VALLEY CAMP OF UTAH, INC.

August 27, 1984

Re: NOV N84-7-6-1 Abatement Measures

FIGURE 1 STAGE CAPACITY CURVE FOR SEDIMENT POND

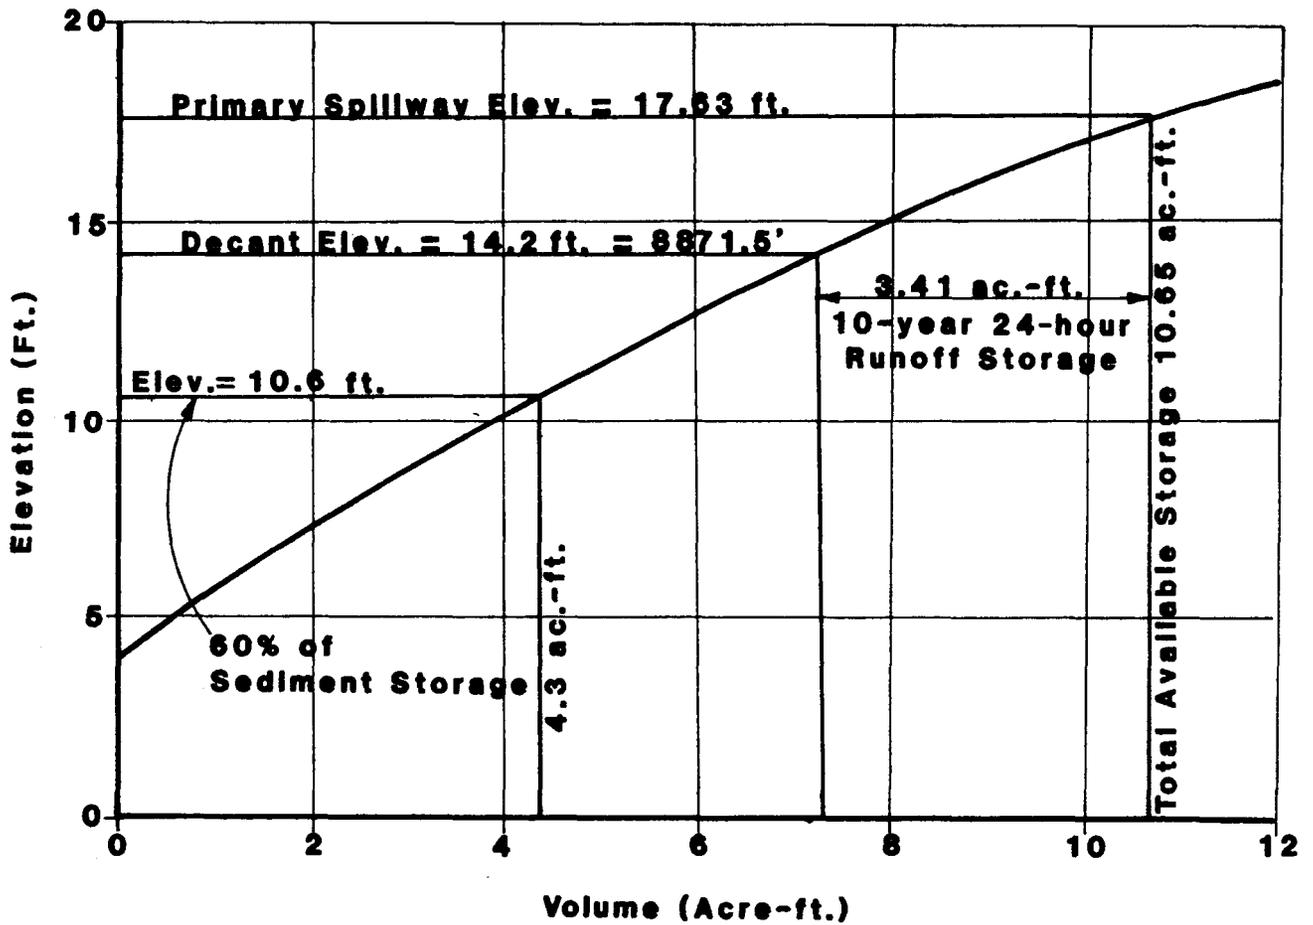
1. It is our intention to clean the sediment pond such that the stage capacity is equivalent to that proposed by Golder and Associates (see attached figure). The required runoff storage volume from the 10-year 24-hour event is 3.41 acre-feet. Therefore, as illustrated on the attached figure, the elevation of the decant orifice will be set at 8871.5 feet.

The original design of the pond, as presented by Golder Associates, was arrived at by calculating a required volume from the design storm (10 year 24 hour) of 6.7 acre feet for runoff, and 3.6 acre feet for sediment volume. This resulted in a total volume requirement of 10.3 acre feet.

In reviewing the Golder information and comparing it with the Vaughn-Hansen Compliance Report, I have found an apparent miscalculation. Using the same formulas as was used by Golder, but changing the required volume of sediment from 3.6 acre feet to 2.75 acre feet (27.5 disturbed acres vs 36.0), and using a new calculated water volume of 3.41 acre feet (as compared to 6.7 acre feet), I come up with a total volume requirement of 6.15 acre feet rather than 10.3 acre feet. Thus, as you can see, the pond as built was considerably oversized.
